Working Party on the Construction of Vehicles

REVISED PROPOSAL FOR DRAFT 06 SERIES OF AMENDMENTS TO
REGULATION No.14
(UNIFORM PROVISIONS CONCERNING THE APPROVAL OF VEHICLES WITH
REGARD TO SAFETY-BELT ANCHORAGES)

Transmitted by the French Delegation

Figure 1 : *Static force application device (S-FAD), isometric views*

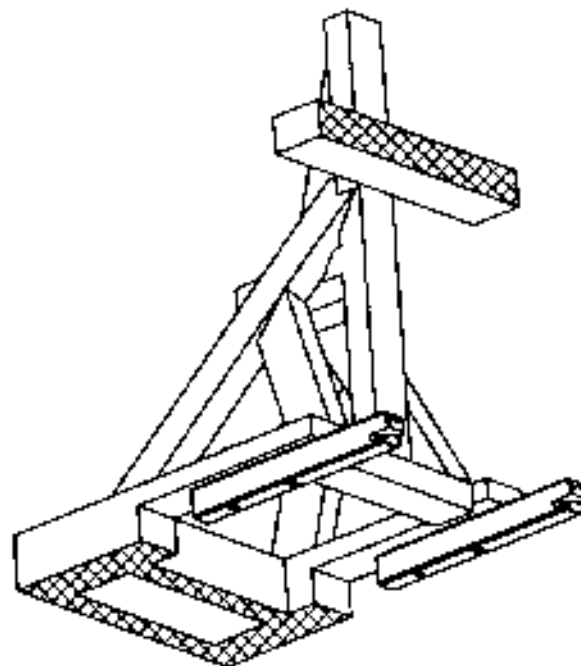
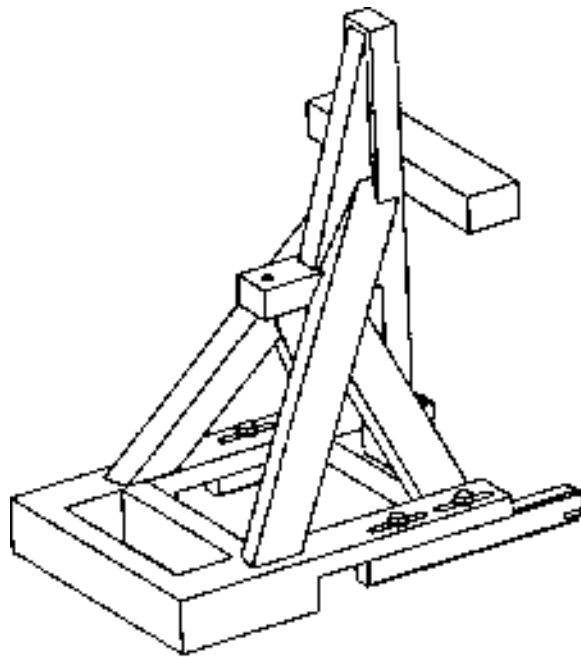
2.22. **“Static force application device (S-FAD)”**
means a test fixture that engages the vehicle ISOFIX anchorages system and that is used to verify their strength and the ability of the vehicle or seat structure to limit the rotation in a static test. The test fixture is describe in the figures 1 and 2.

Justification : rewording in a more realistic manner of the S-FAD definition.

Figure 2 : Static force application device (S-FAD), dimensions

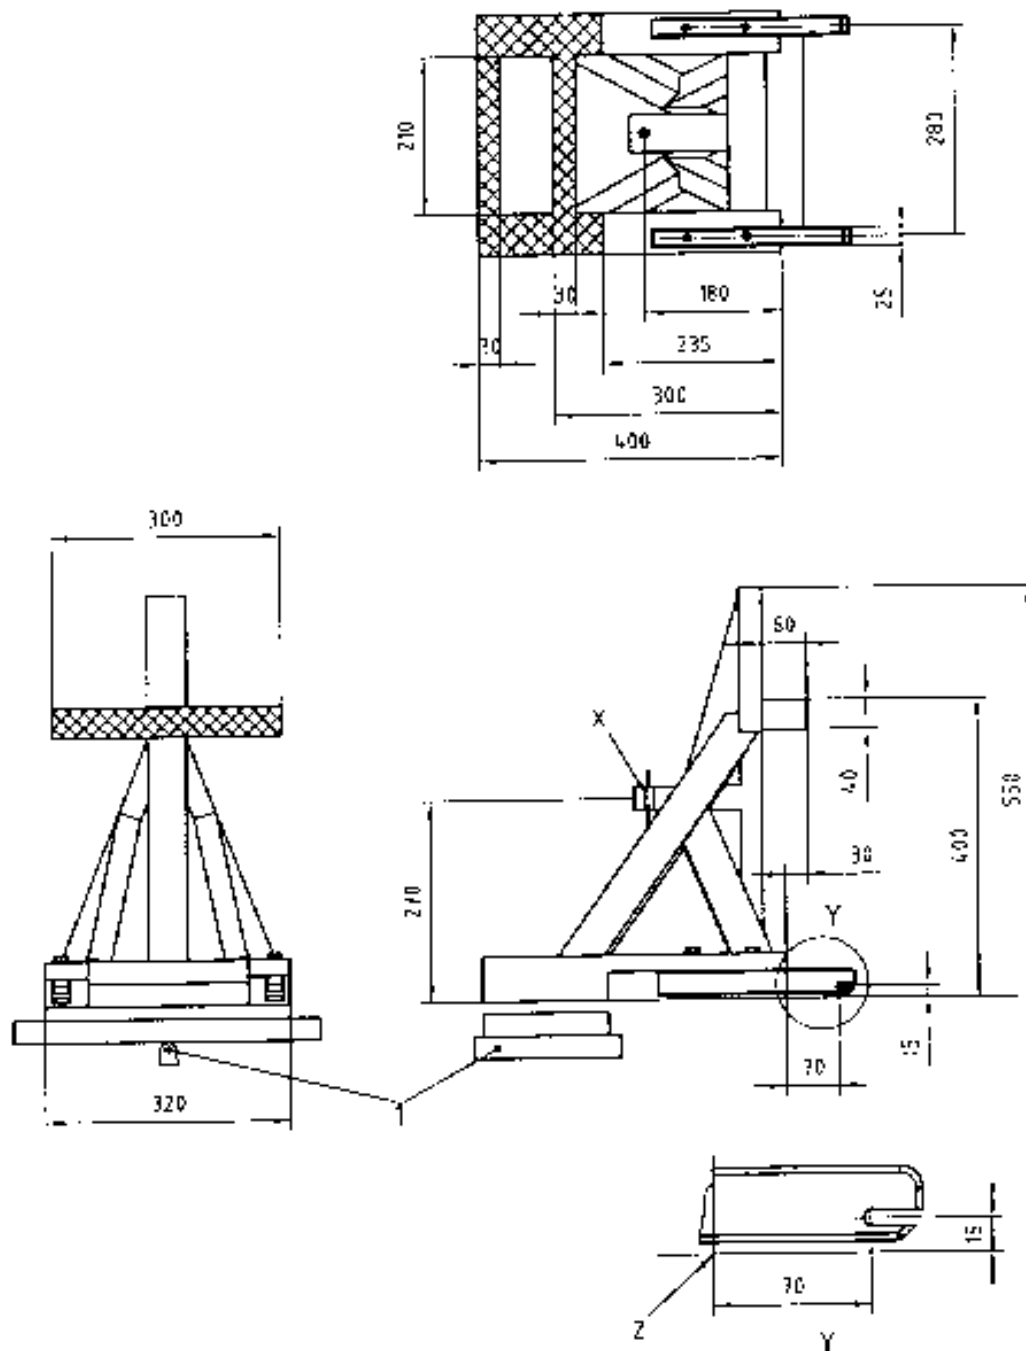
Stiffness of S-FAD : When attached to rigid anchorage bar(s) with the front cross member of the S-FAD supported by a rigid bar that is held at the centre by a longitudinal pivot 25mm below the S-FAD base (to allow bending and twisting of the S-FAD base) the movement of point X shall not be greater than 2 mm in any direction when forces are applied in accordance with table n°1 of paragraph 6.6.4. of this regulation. Any deformation of the ISOFIX anchorages system shall be excluded from the measurements (e.g. the stiffness requirements will be fulfilled when using a securely welded construction consisting of rectangular 3mm steel tubing, and 6mm thick load application plate).
